### ADDENDUM 1

CSP 22-92

## Cavazos Elementary School Heating & Air Condition (HVAC) Improvements Funded through the Elementary & Secondary Emergency Relief (ESSER) Funds May 31, 2022

## Addendum

EDINBURG CONSOLIDATED INDEPENDENT SCHOOL DISTRICT  
**CAYETANO CAVAZOS ES - HVAC IMPROVEMENTS**  
 1501 FREDDY GONZALEZ DR, MCALLEN, TX 78504

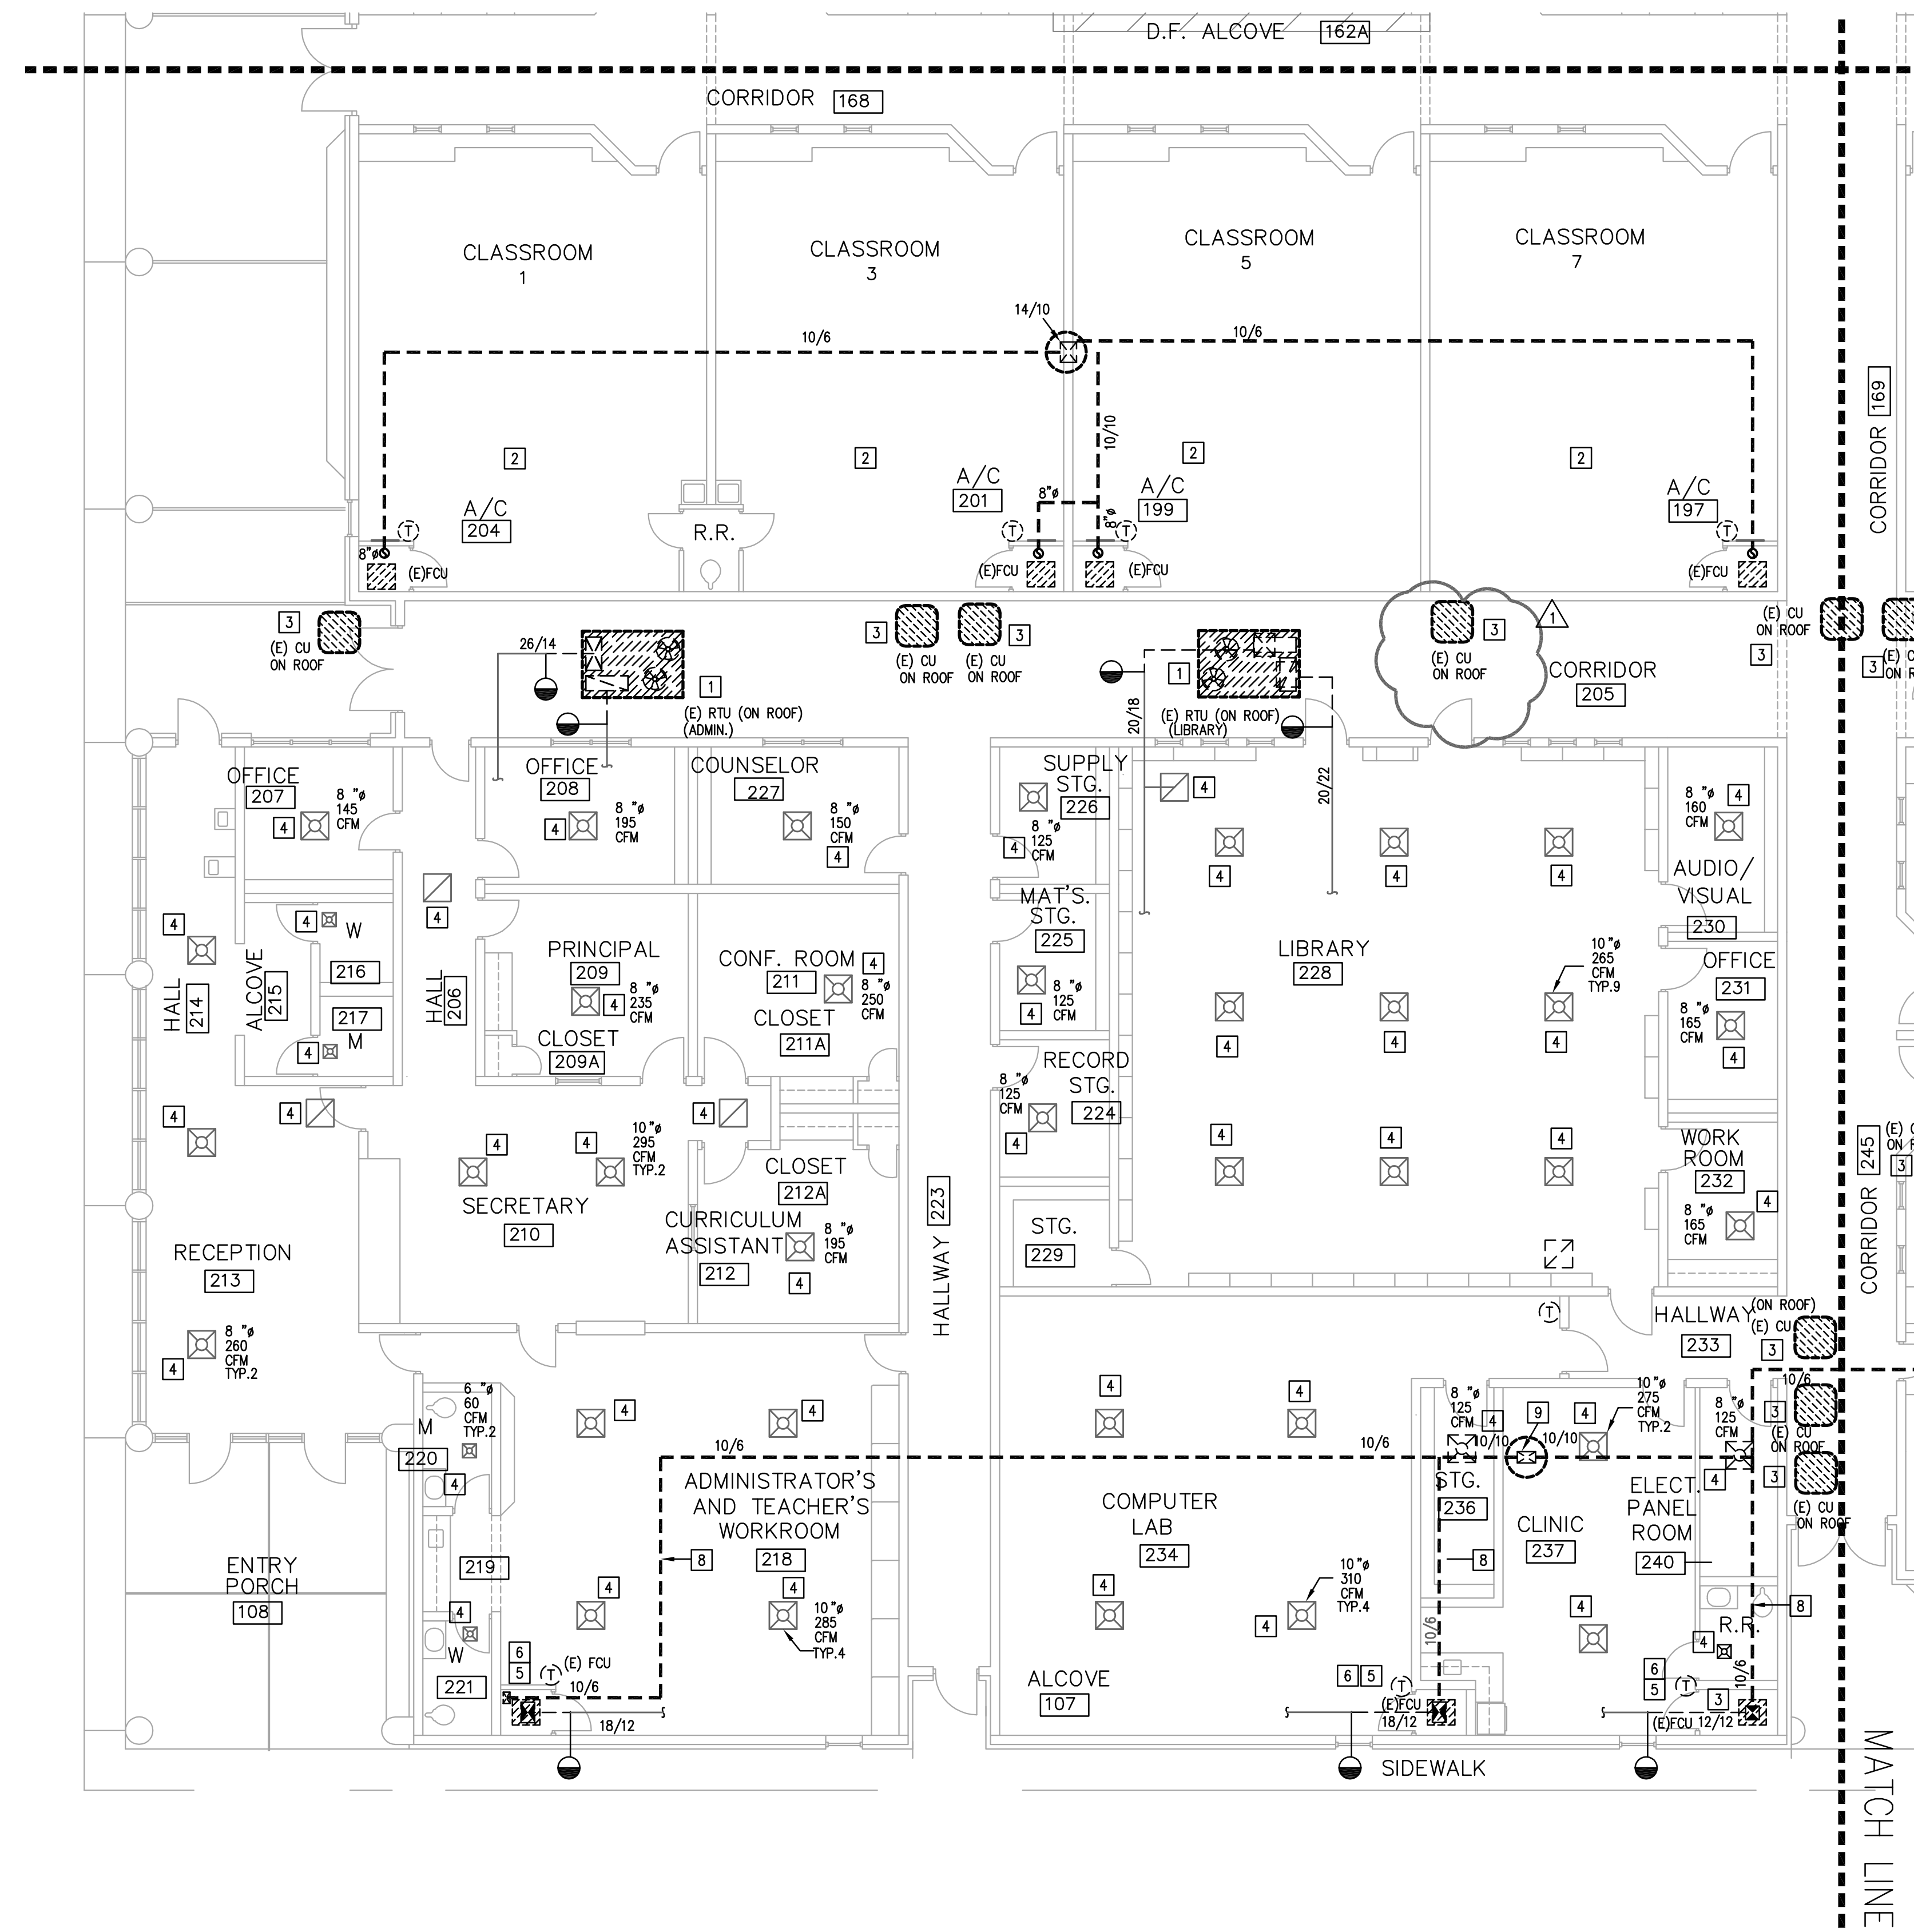
#### MD2.12B – Level 1 Mechanical Plan – Demolition – Area B

- A. Revised keyed notes 3, 4, 5.

DATE: 05/05/2022  
 DRAWN BY: DBR  
 CHECKED BY: DBR  
 PROJECT NUMBER: 218007.005  
 SHEET TITLE: LEVEL 1 MECHANICAL PLAN - DEMOLITION - AREA C  
 SHEET NUMBER: MD2.13C

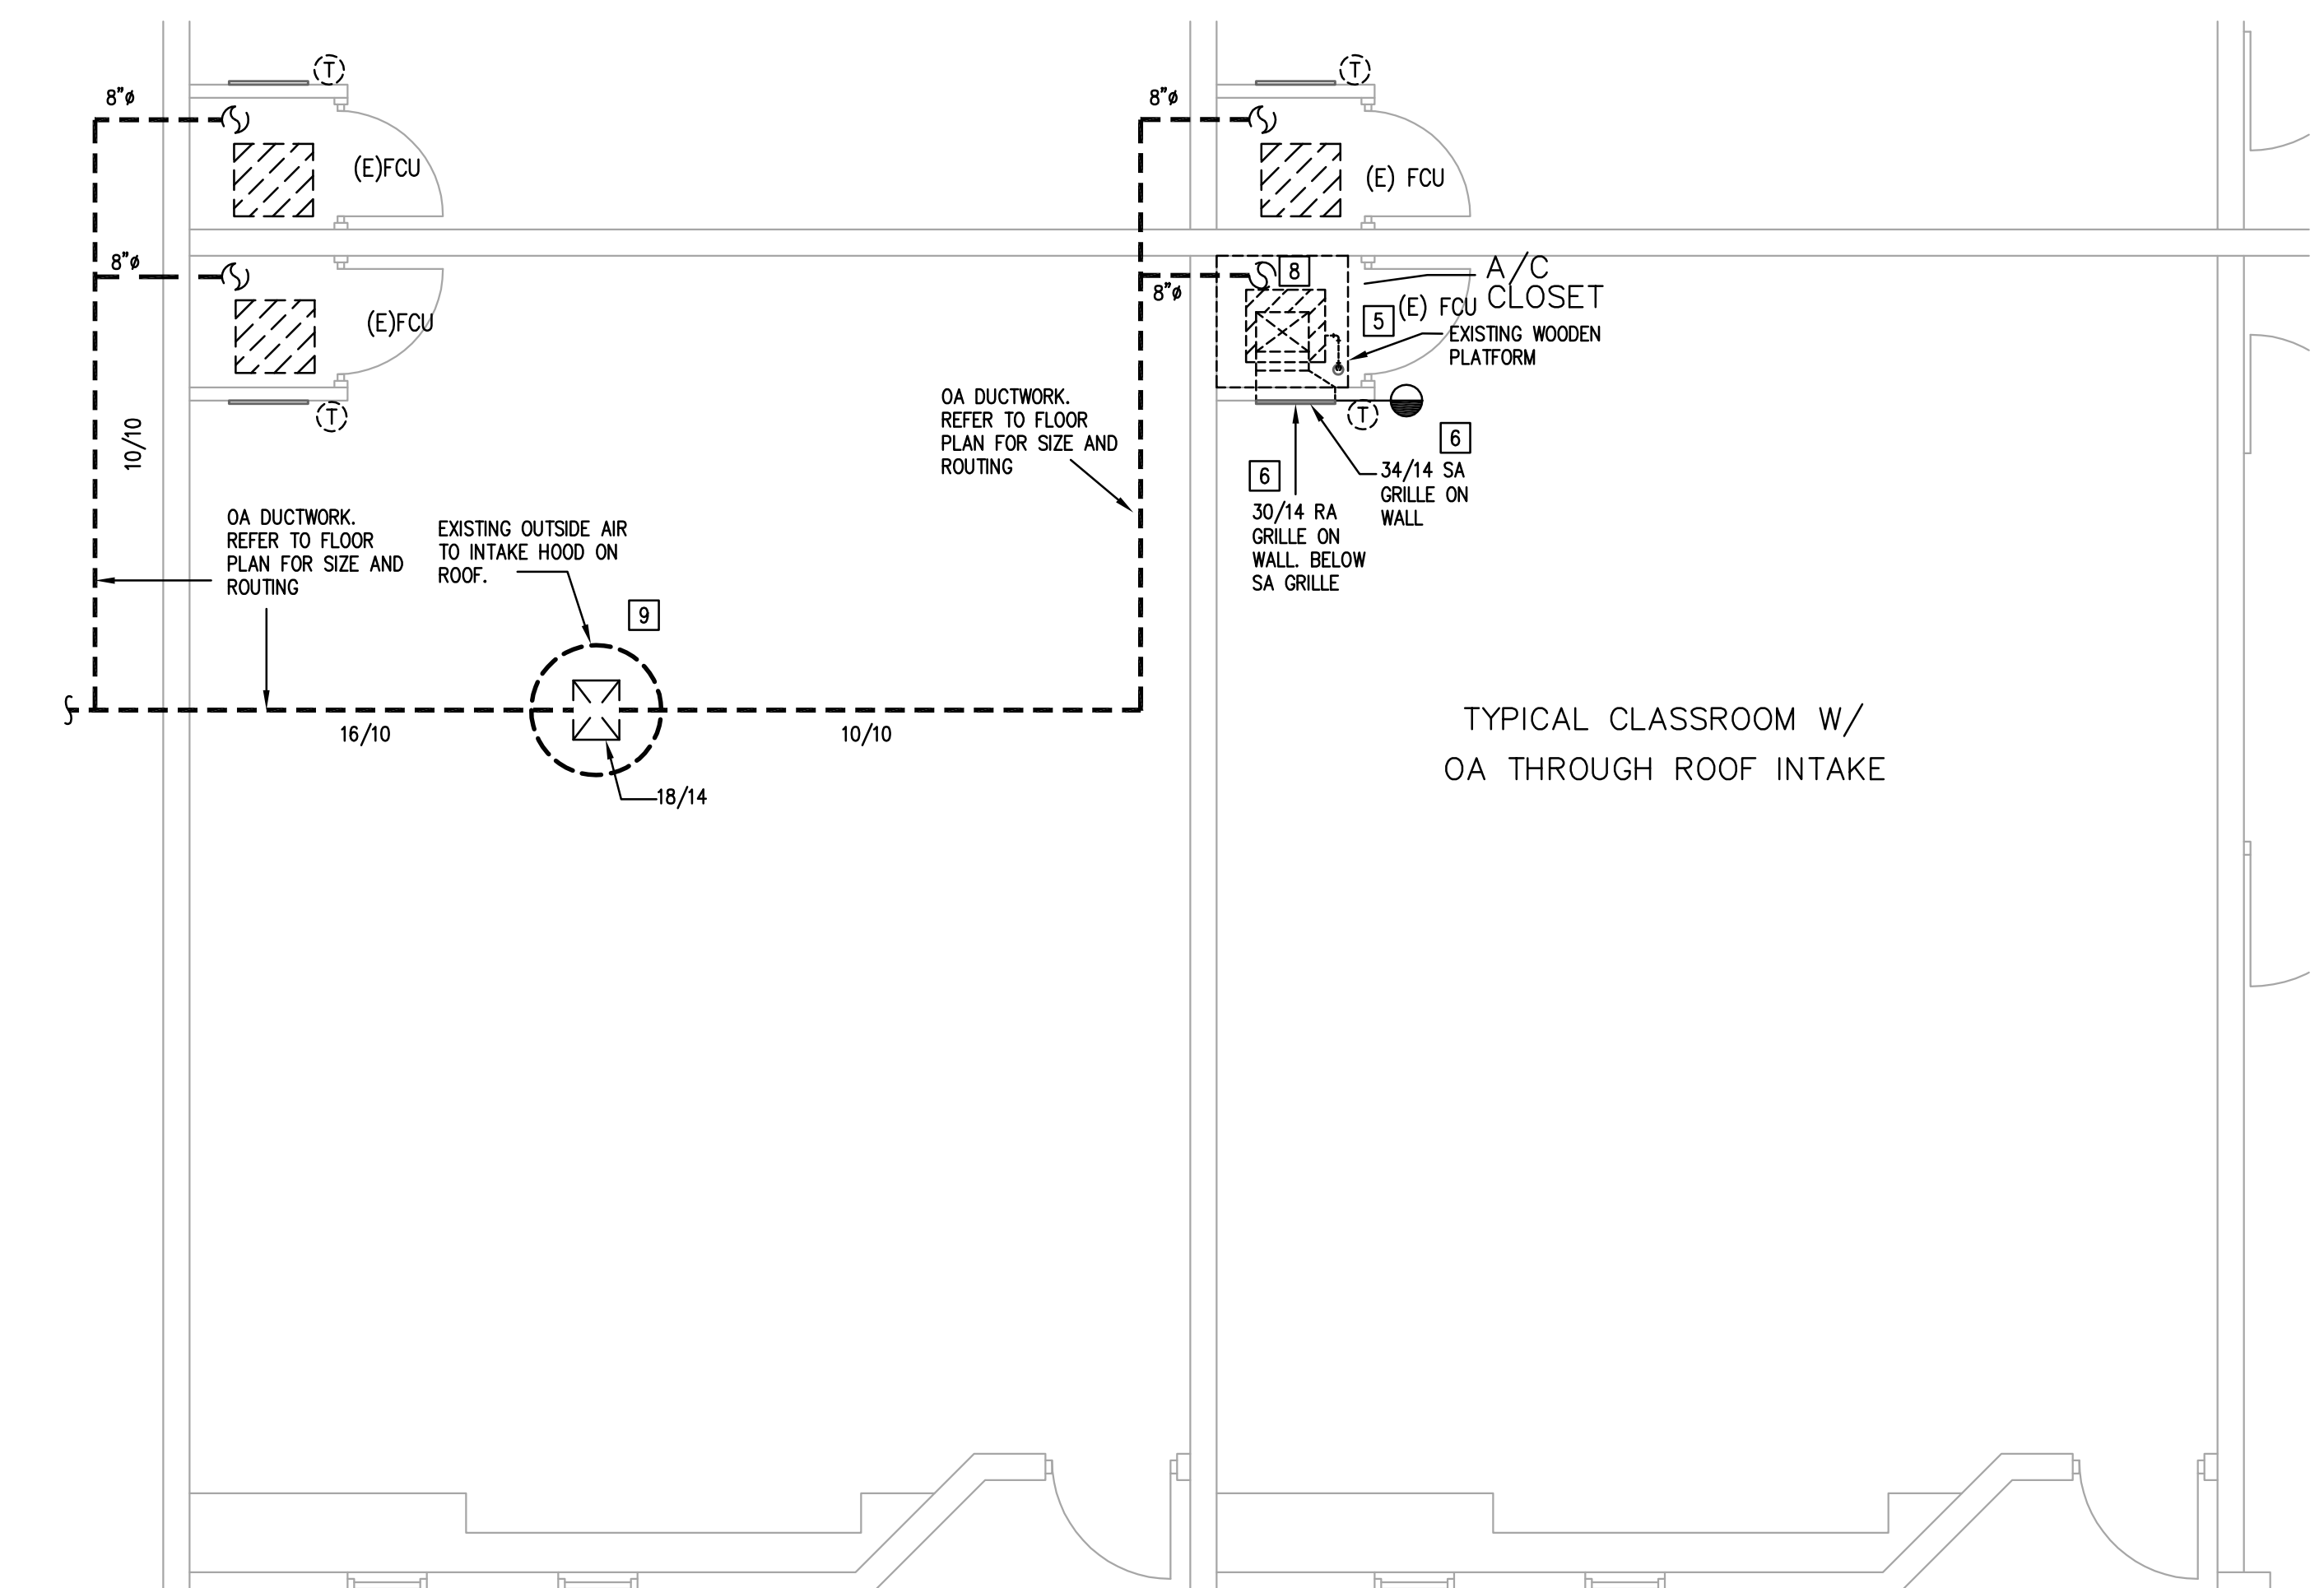
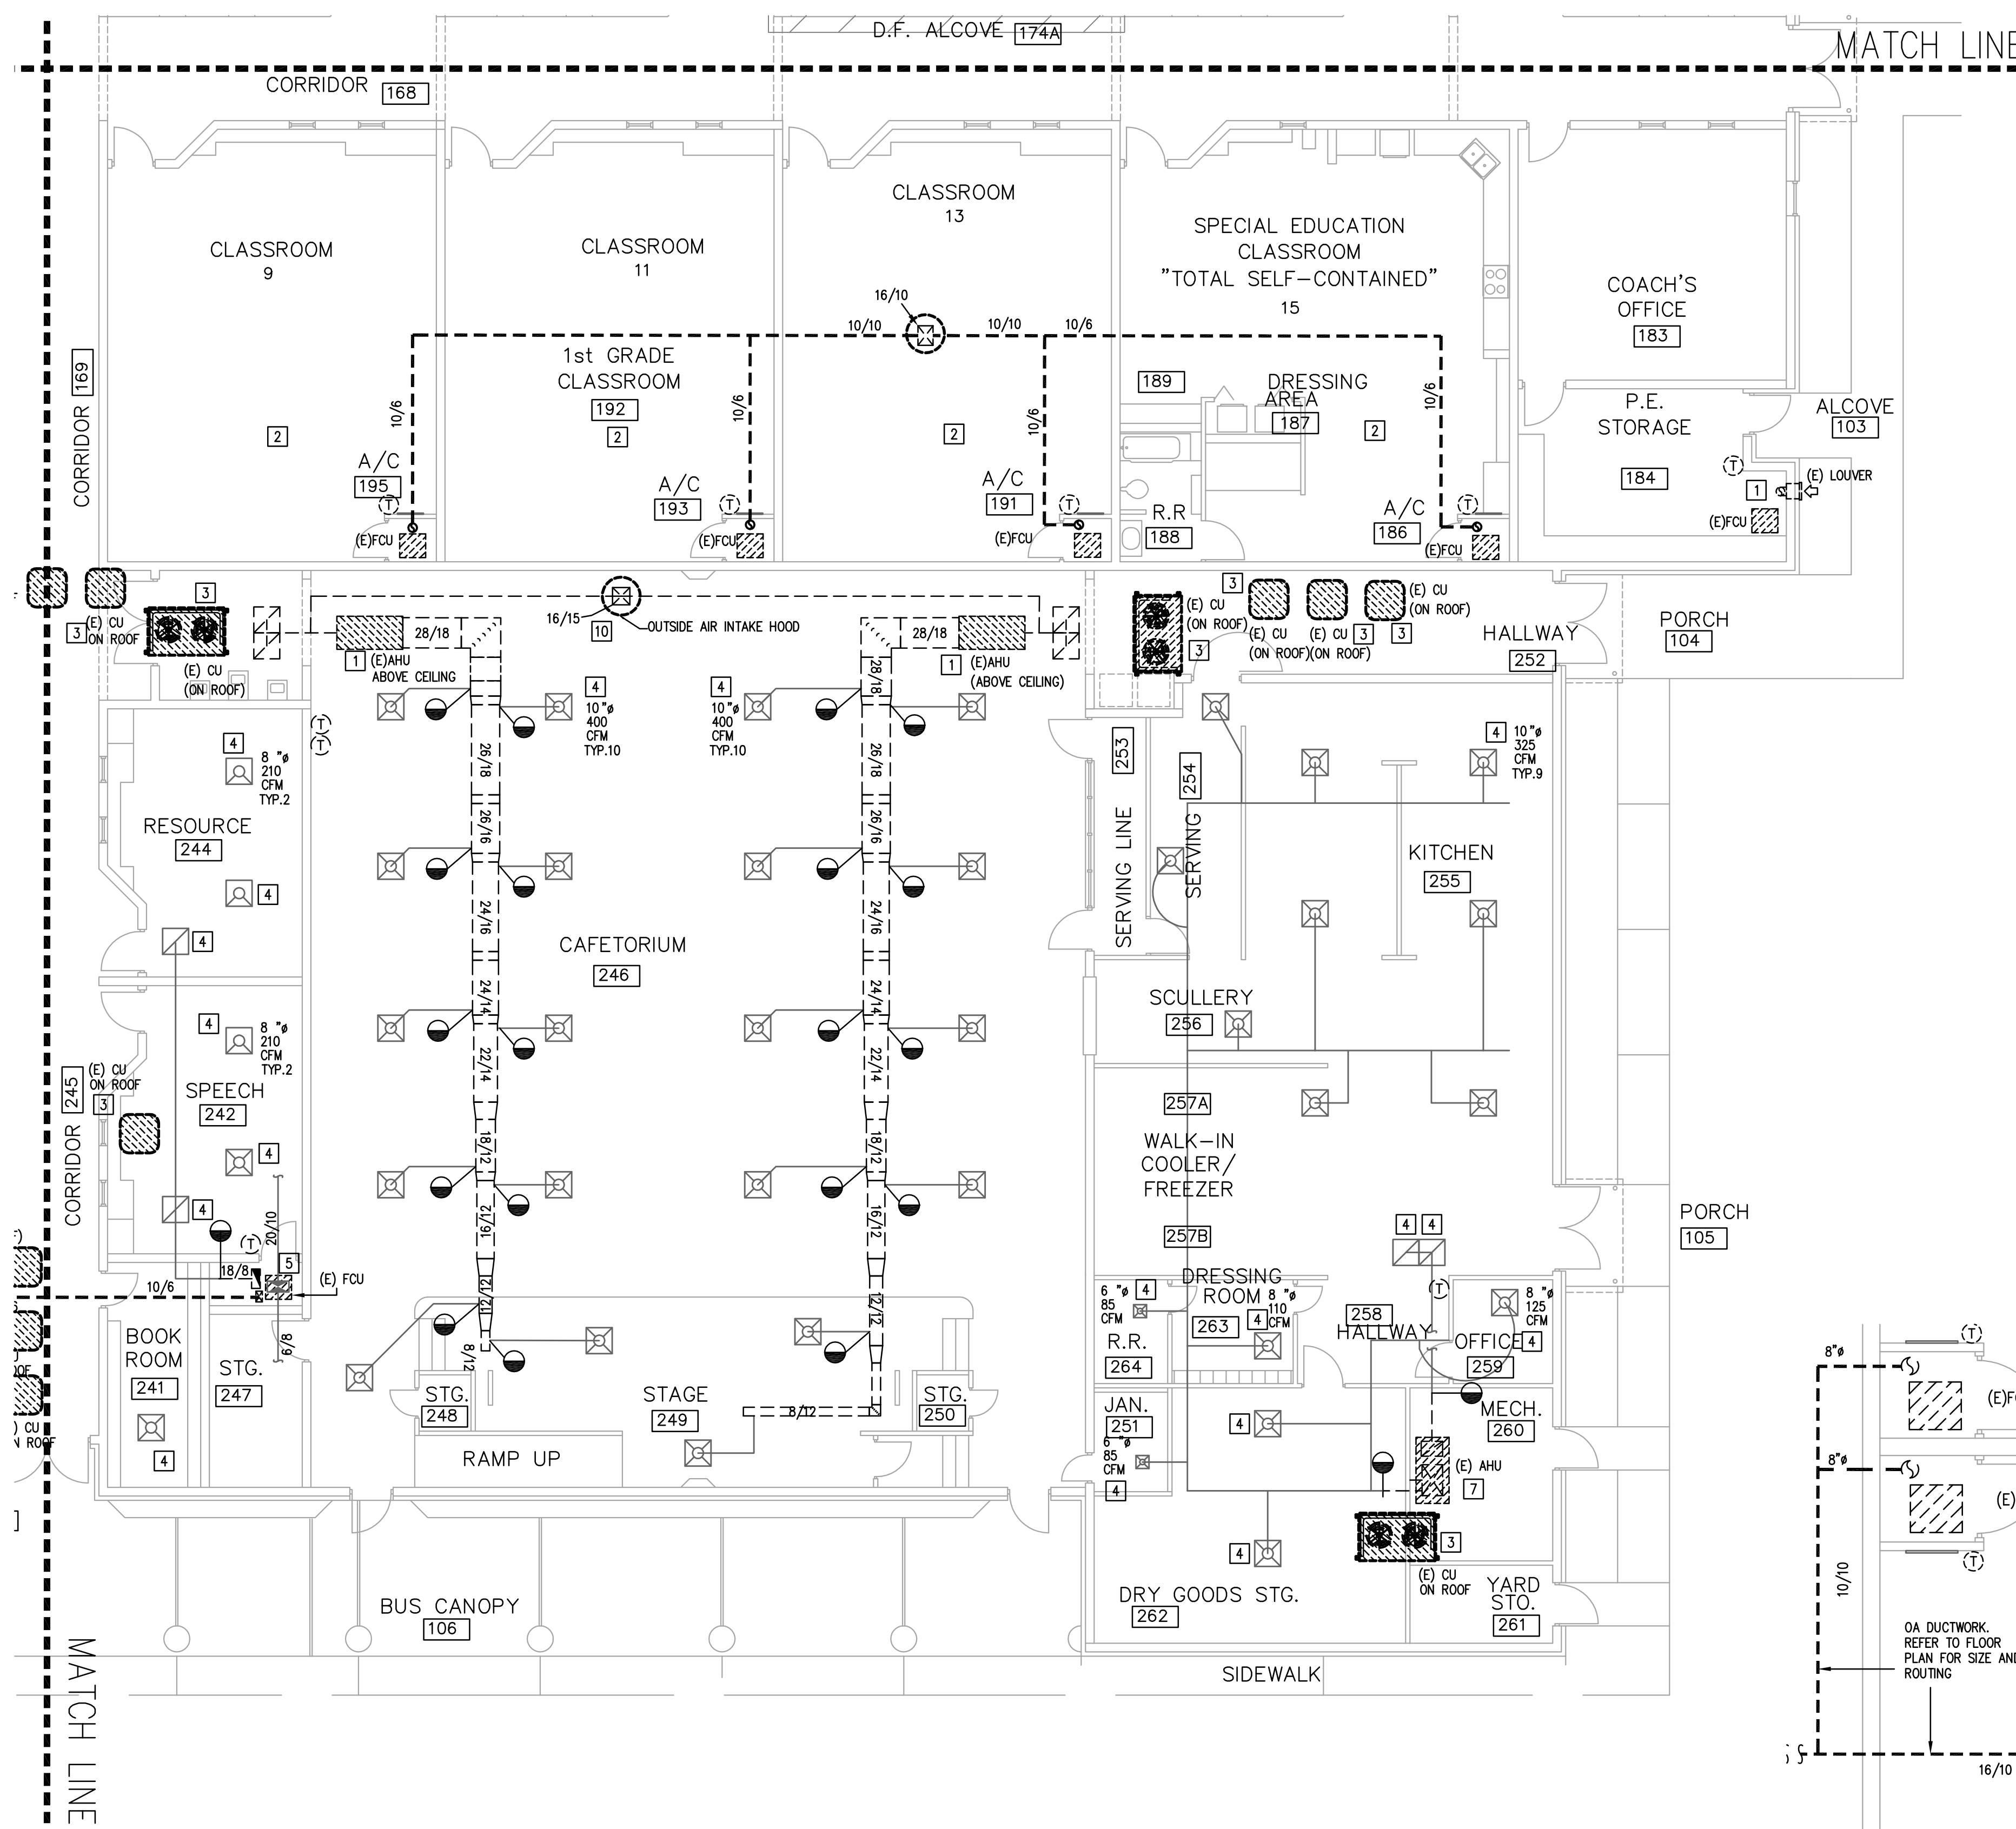
#### MD2.13C – Level 1 Mechanical Plan – Demolition – Area C

- A. Revised keyed notes 1, 3, 5.  
B. Corrected keyed note on existing condensing unit on roof.
